TECHNICAL SERVICE BULLETIN

Unintended Exterior Mirror Movement In Wet Weather Conditions - Moisture In Exterior Mirror Connector

17-2225

08 November
2017

Figure 1

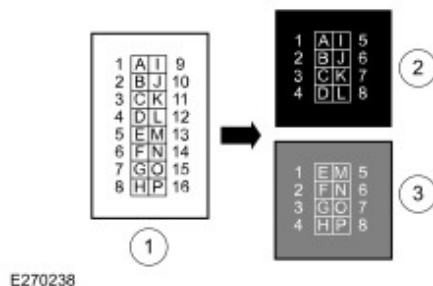
1. Remove the affected exterior mirror. Refer to WSM, Section 501-09.
2. Remove the original 16-pin mirror connector by cutting the wires 13 mm (1/2 inch) from the connector and splice to the 8-pin gray and 8-pin black male connector pigtails by following the wiring repair kit instructions included with the pigtail kit. (Figure 1 Connector Face)

3. Remove the original 16-pin door harness mirror connector by cutting the wires 13 mm (1/2 inch) from the connector and splice to the 8-pin gray and 8 pin black female connector pigtails by following the wiring repair kit instructions included with the pigtail kit. (Figure 1 Connector Face)

(1). To gain enough access to perform the splices, pull the harness connector through the wire harness grommet hole below the access hole for the mirror bolts.

(2). Using a small flat head screwdriver, remove the white christmas tree body-to-connector retainer from the original connector and install it on the replacement gray female connector.

(3). Tape the female connectors together using electrical or foam tape.
